CUY/SUM-480/91-29.69/19.07

STRUCTURE NOTES SUM-480-0137, SUM-480-0205L, SUM-480-0208R, SUM-82-0727, SUM-480-0481L, SUM-480-0481R, SUM-480-0672, SUM-480-0814	
SFN DESIGN AGENCY	
DESIGNER CHECKER BFR REVIEWER RAB 07/12/21 PROJECT ID 110698 SUBSET TOTAL 4 11 SHEET TOTAL P.22 29

3/4"	OVERLAY (CONCRETE ECK SURFA	ACED)		SUPER STRUCTURE DETAILS BRIDGE NO. SUM-480-0205L & SUM-480-0208R FEATURE INTERSECTED: CHAMBERLIN RD
	SLABS			SFN DESIGN AGENCY DESIGNER CHECKER BFR REVIEWER XXX MM-DD-YY PROJECT ID 110698 SUBSET TOTAL 9 11 SHEET TOTAL P.27 29

PROFILE CORRECTION PLAN AT STRUCTURES

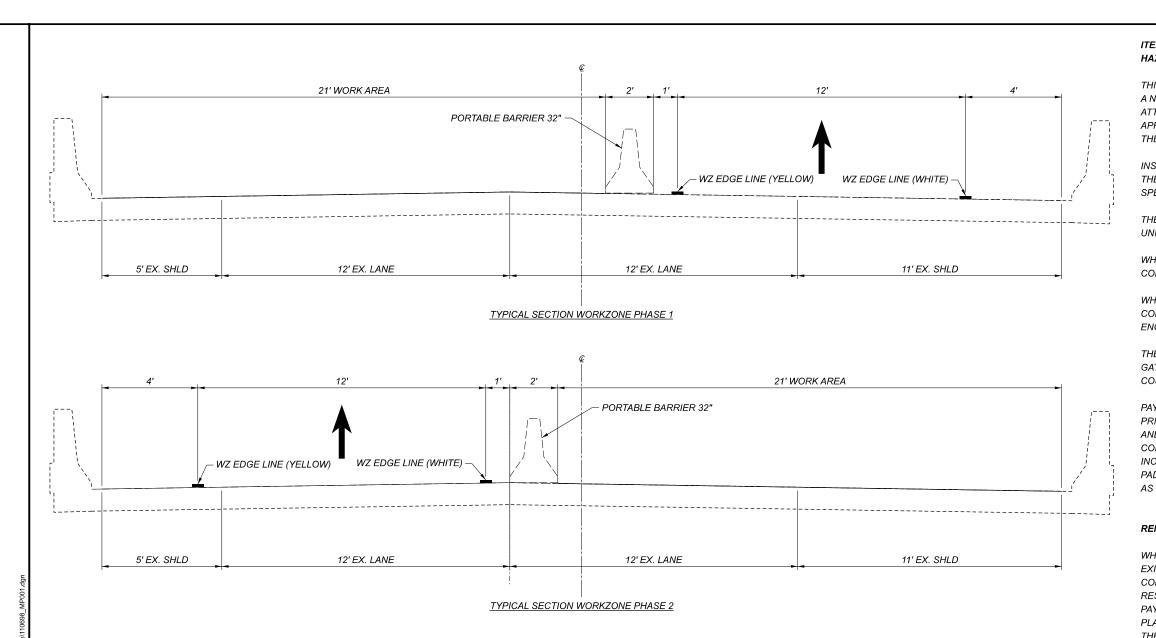
Added to address leveling needed at mainline structures overpassing Stow rd.

THE CONTRACTOR MUST PROFILE THE EXISTING PAVEMENT IN EACH LANE PER THE "SURFACE SMOOTHNESS FOR BRIDGES AND APPROACHES" NOTE IS THIS PLAN. SUBMIT A PROFILE CORRECTION PLAN TO INCLUDE VARIABLE DEPTH MILLING AND VARIABLE DEPTH ASPHALT AS NEEDED TO THE ENGINEER FOR APPROVAL PRIOR TO CONDUCTING THE PROFILE CORRECTION WORK CORRECT THE PAVEMENT PROFILE BY CONSTRUCTING A SMOOTH TRANSITIONING PAVEMENT AT A MINIMUM OF 1 1/2" THICK AND NOT MORE THAN 2" THICK, FOR A DISTANCE OF 100 LINEAR FEET BEGINNING AT THE APPROACH SLAB, A MINIMUM OF 12" FROM THE DECK END, AS NEEDED.
